Christchurch Eq RAPID Assessment Form - LEVEL 2

91A Cashel St.

CHRISTCHURCH CITY COUNCIL ENFORCEMENT TEAM NOTICES COVERSHEET	Christchurch City Council
--	-------------------------------------

Notices under the Building Act 2004 not to use or occupy your building and to repair your building
91A Cashel Street

Sketch (optional)

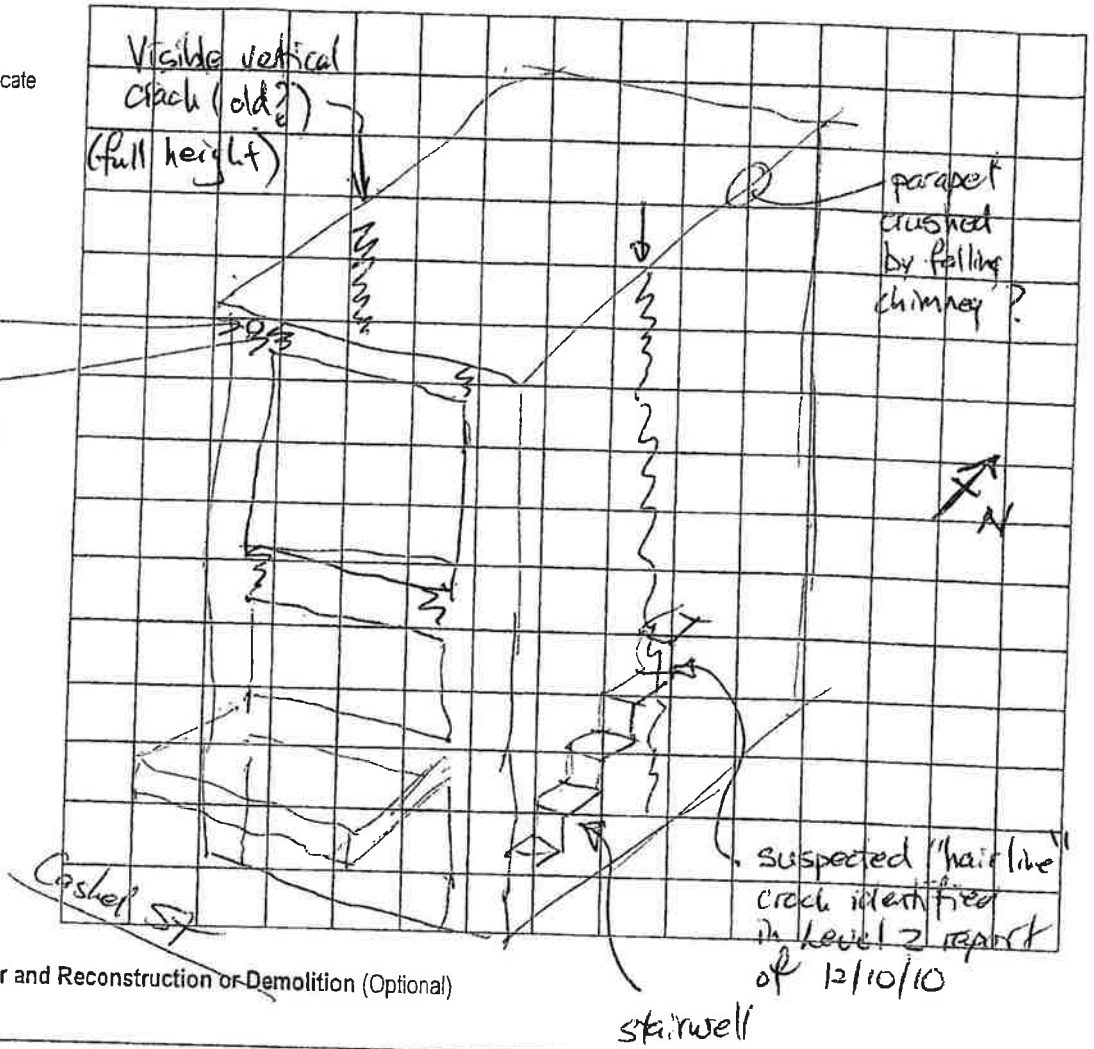
General Comment Request was to inspect vertical crack in stairwell east side ^{well}, but not accessible (previous level).
 Noted, vertical crack in west wall similar location to inferred east wall.
 Other cracks in street frontage at joint between walls and horizontal members.
 Brickwork exposed beneath plaster (a lot of work to find these exposures, so examine photos carefully). How building ~~from~~ works structurally not clearly understood and requires further study.

exposed face brick (see photo) cracks (see photo)

Called to inspect "hairline" crack in stairwell, but could not gain access.
 Phone contact for access given as Tracy Brough Ph 355 9566
 Suspect mechanism for this crack same as crack observed on opposing side of bldg.
